Service Bulletin

SUBJECT: Service Update for Inventory and Customer Vehicles
Insufficient Evaporative Emission Canister Capacity for Vapor Generation

MODELS: 2014-2015 Cadillac ELR
2011-2015 Chevrolet Volt
Expires With Applicable New Vehicle Limited Warranty Coverage Periods,
Including Voltec Component Limited Warranty

Subject: 14522B – Service Update Bulletin
Insufficient Evaporative Emission Canister Capacity for
Vapor Generation
Revised Part Information, Service Procedure and Warranty
Transaction Information Sections

2440830

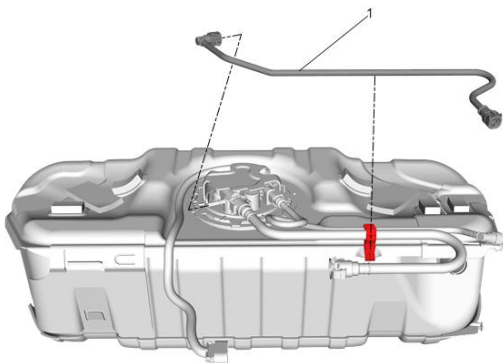
1. Remove the evaporative emission canister (1). Refer to *Evaporative Emission Canister Replacement* in SI.

4. Install a new evaporative emission canister (1). Refer to *Evaporative Emission Canister Replacement* in SI.

3997266

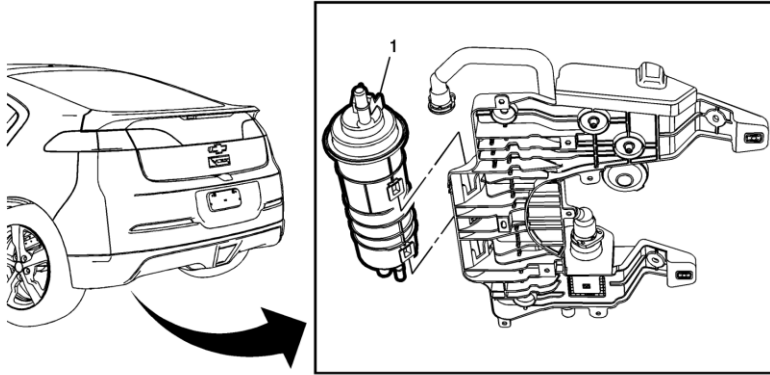
2. Remove the evaporative emission hose (1). Refer to *Evaporative Emission Hose Replacement* in SI.
3. Install a new evaporative emission hose (1). Refer to *Evaporative Emission Hose Replacement* in SI.
